APPLICATION FOR PERMISSION UNDER SECTION 16 OF THE TOWN PLANNING ORDINANCE (CAP. 131)

For Official Use Only 請勿填寫此欄	Application No. 申請編號	A / NE - MKT / 56
	Date Received 收到日期	14 NOV 2025

Planning Statement
S.16 Application for the
Proposed Temporary Warehouse for the Storage of Car Parts
And
Associated Filling of Land
for
A Period of 3 Years
At
Lot 664 S.A and Adjoining Government Land
In
DD 90
Man Kam To, New Territories

寄件者: TsangShun Qi <[REDACTED]>
寄件日期: 2025年11月19日星期三 11:27
收件者: Cheryl Tsz Man TSANG/PLAND
主旨: Submission of revised No. A/NE-MKT/56 document
類別: Internet Email

Layout plan

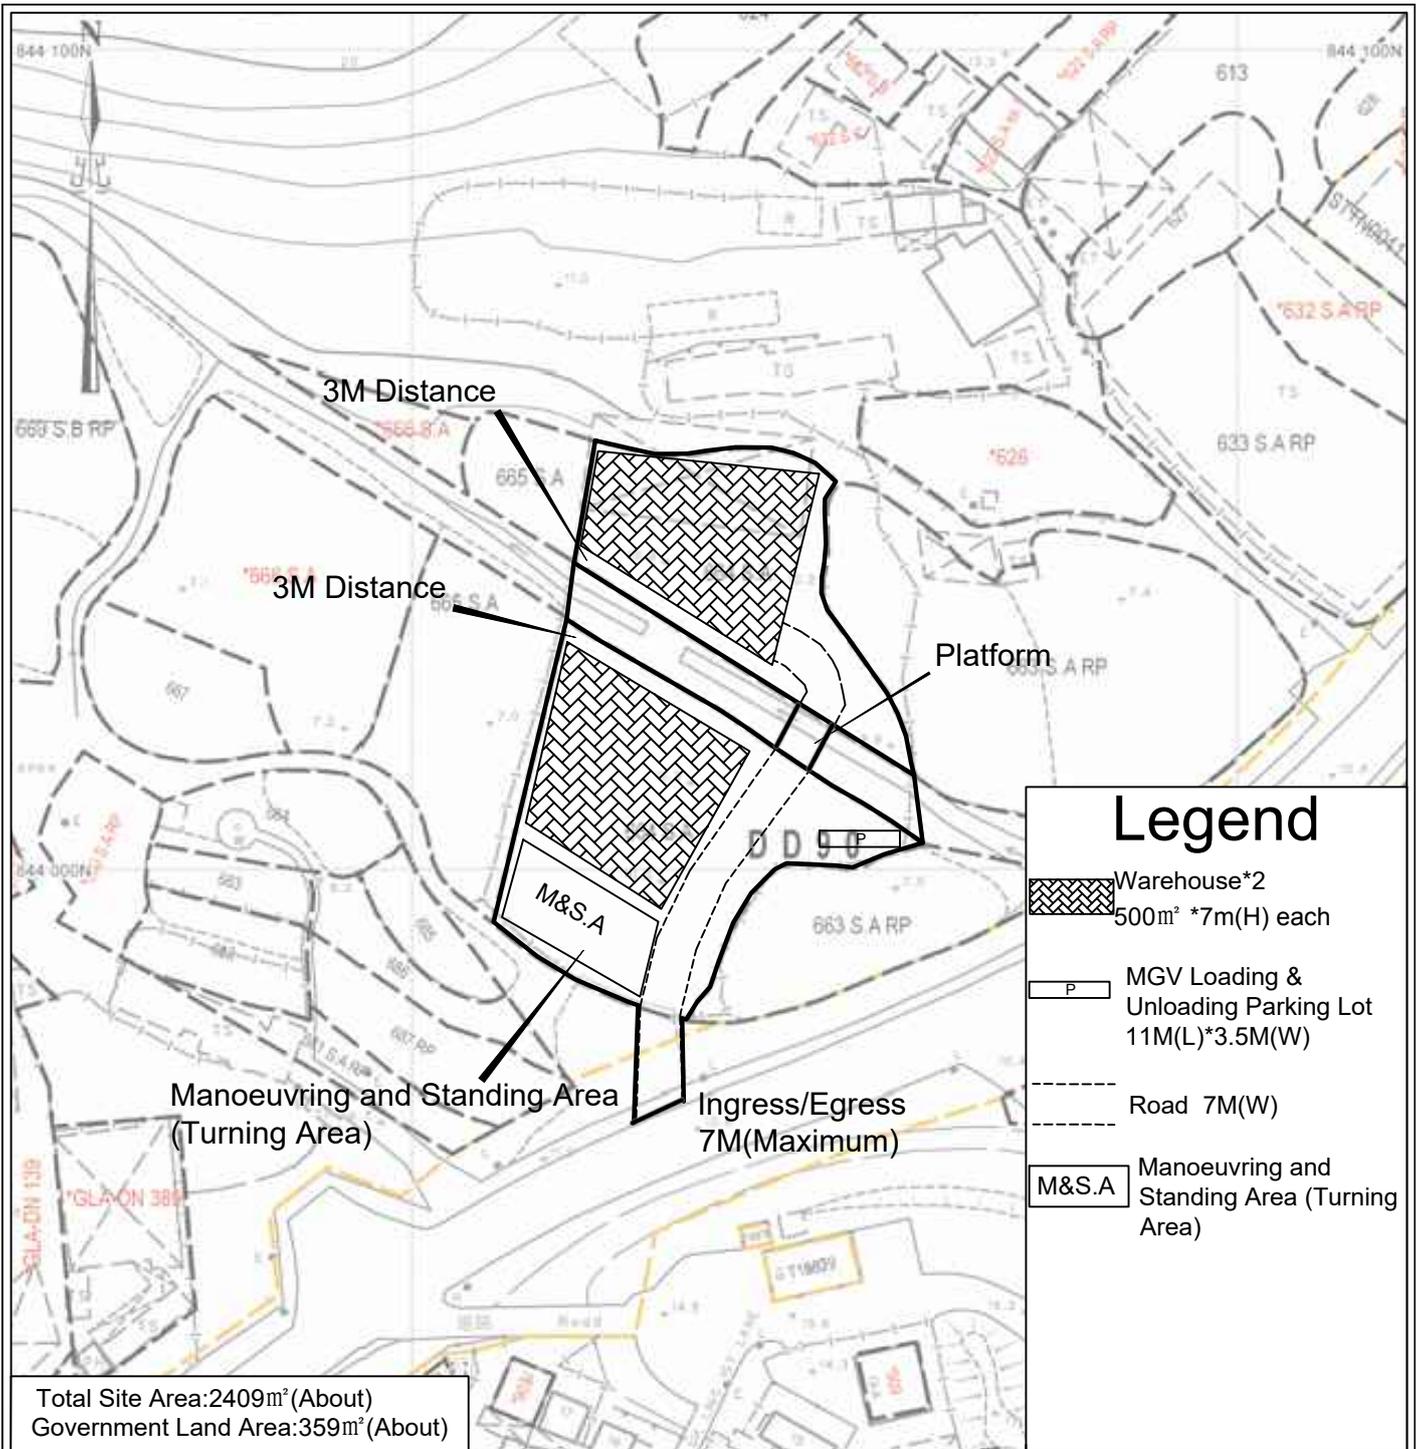
Regarding to the DSD comments, we note and we agree to extend the site area to include proposed drainage improvements works for consistency purpose. The updated Layout Plan & Application form are attached for your review.

f. Layout plan refers. Please advise whether the proposed new platform shall have any supporting structure erected within the proposed trapezoidal channel, which may affect the hydraulic performance;	The new platform stated in the layout plan to solely above the proposed trapezoidal channel that would not affect the hydraulic performance.

Swept Path Plan

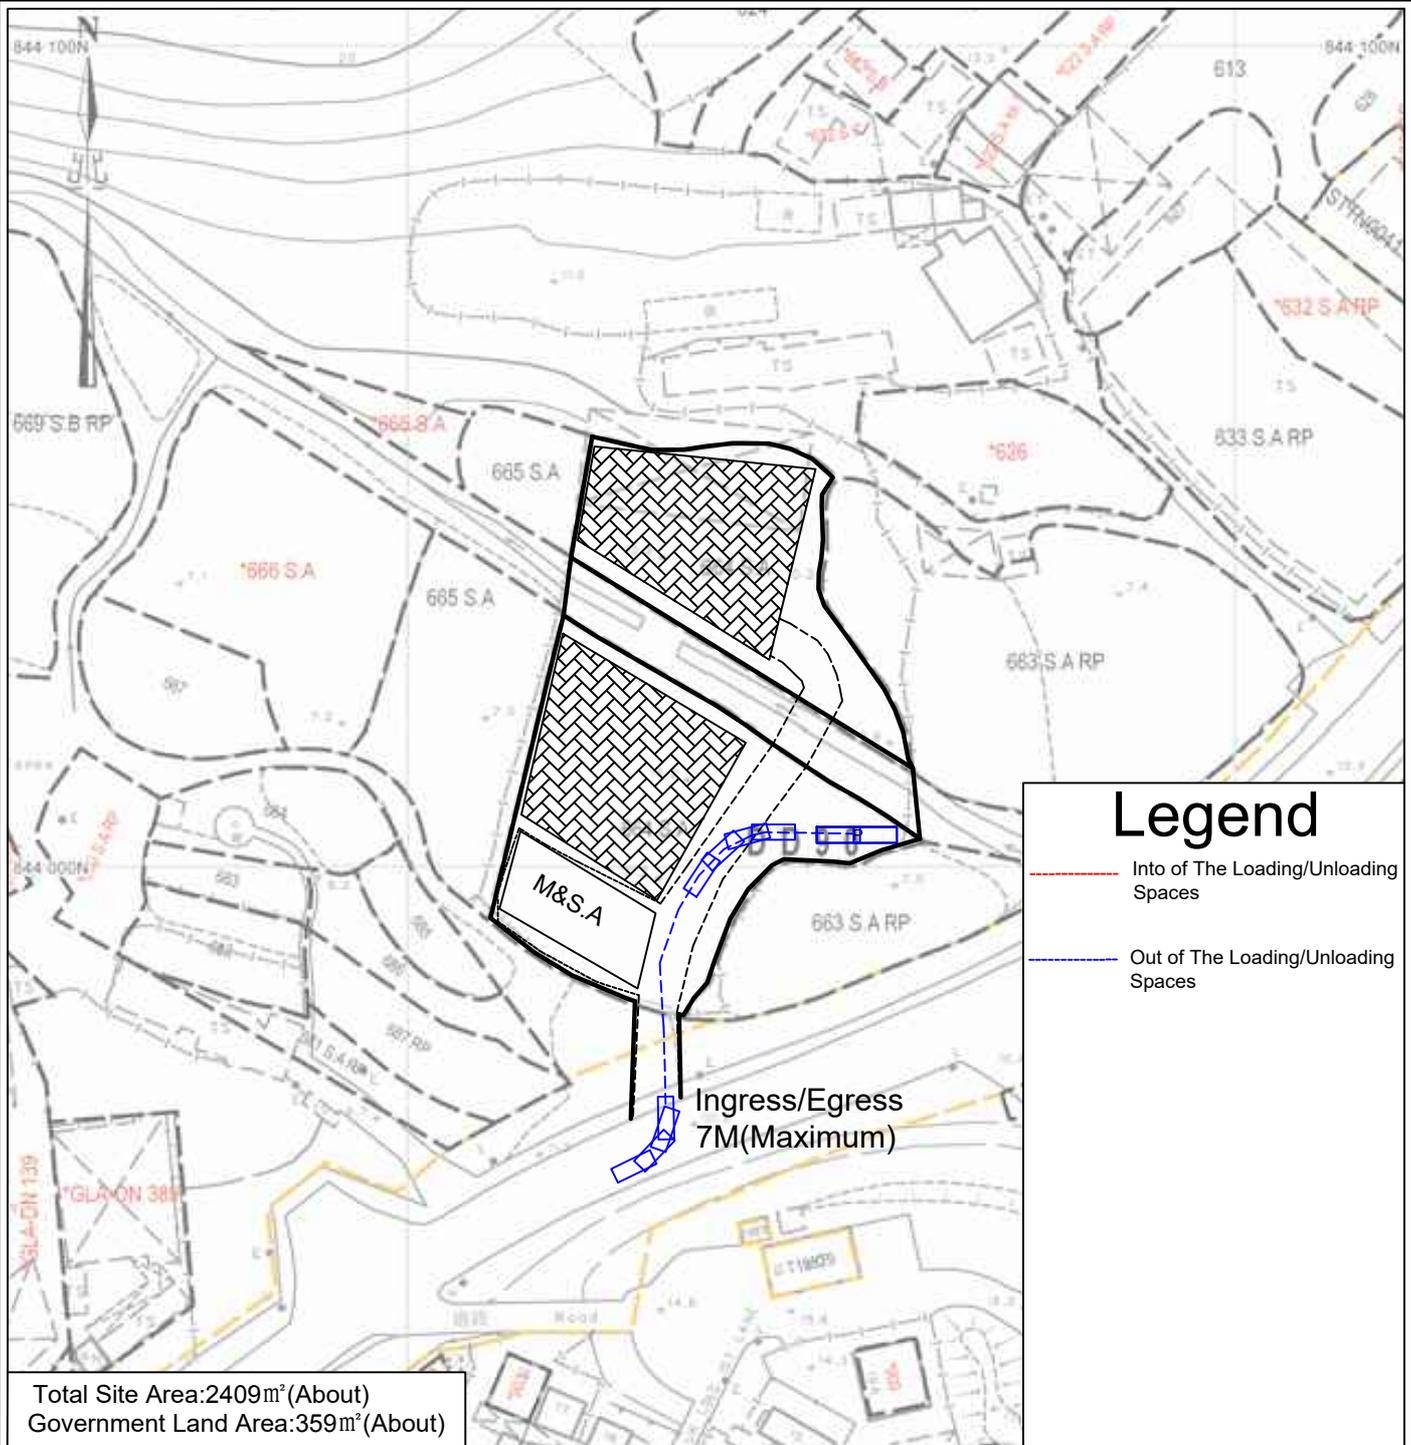
<p>(iii) The applicant shall provide a proposal on the vehicular access arrangement including the run-in/out design for the vehicles leaving/entering the proposed use;</p>	<p>Refer to the Vehicular Access Arrangement proposal.</p>
		<p>(iv) The applicant shall demonstrate the satisfactory maneuvering of the goods vehicles entering and existing the Site, maneuvering within the Site and into/out of the parking and loading/unloading spaces, preferably using the swept path analysis;</p>	<p>Refer to the Swept Path Plan</p>

Appendix A - Site Photos

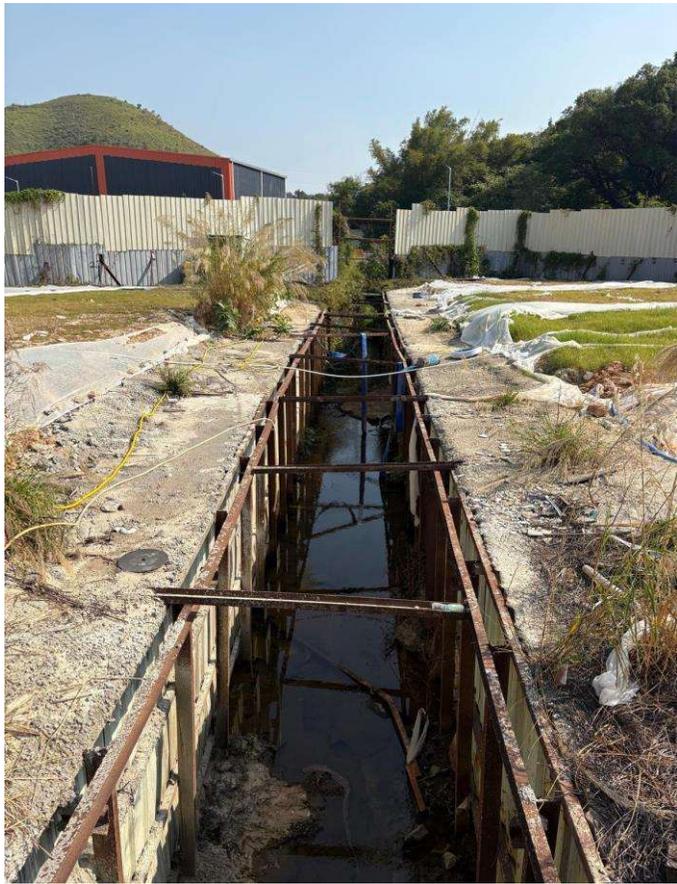
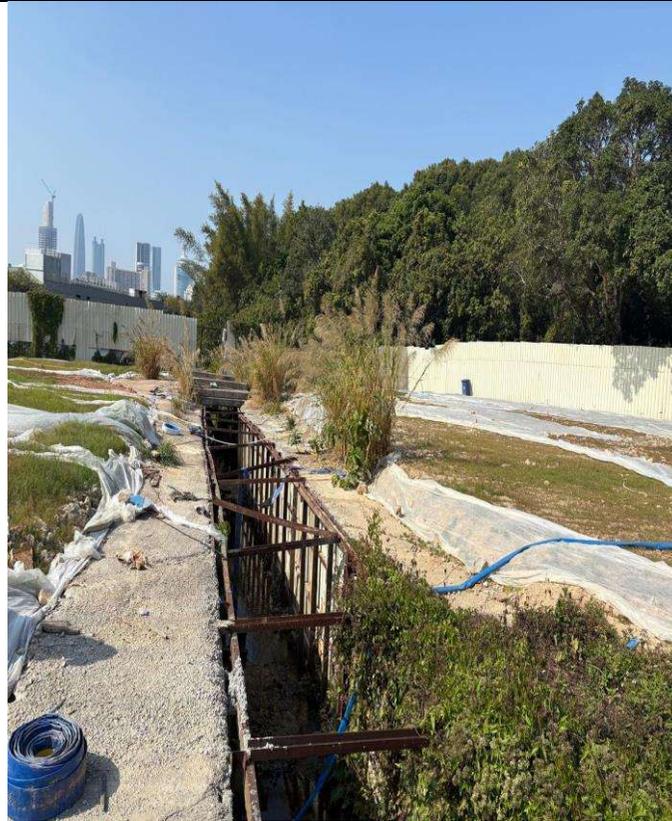
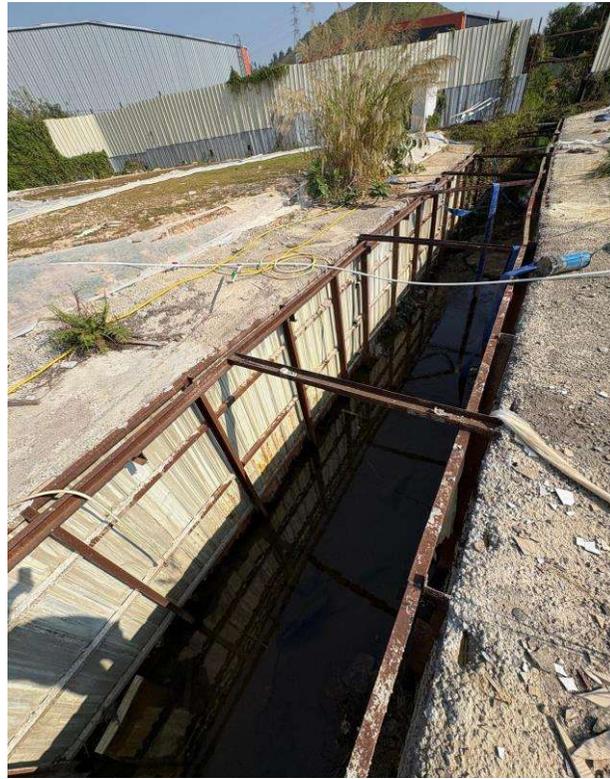
05-01-2026	<p>The applicant should provide more site photos with different viewpoints to confirm whether the whole watercourse within the application site is already modified.</p>	<p>The whole watercourse within the application site be constructed to an existing 2.1m(W) x2.7m(D) open channel.</p> <p>In this S16 application, the applicant has submitted a proposal to the Drainage Services Department to modify the existing open channel into a trapezoidal channel. Construction has not yet commenced.</p> <p>All site photos refer to Appendix A</p>

e. Please provide more photos to demonstrate the condition of the existing streamcourse, immediate upstream and further downstream, and surrounding environment of the Site;	More photos are provided.
